NPDES Permit Application No. TX0074012, Bryan Mound SPR Oil Storage Response to the Request for Additional Information

NPDES Permit Application No. TX0092827, Big Hill SPR Oil Storage Response to the Request for Additional Information

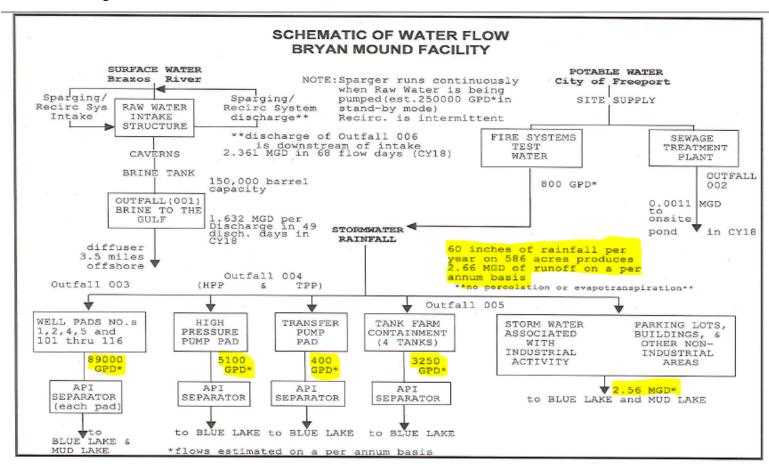
3. Please clarify why flow was marked as "N/A" for Outfalls 003, 004, and 005.

Flow is not a parameter on the current NPDES permit, as these discharges are primarily from stormwater. Please review the below schematic in which an estimated rainfall and flow amounts are given for 2018.
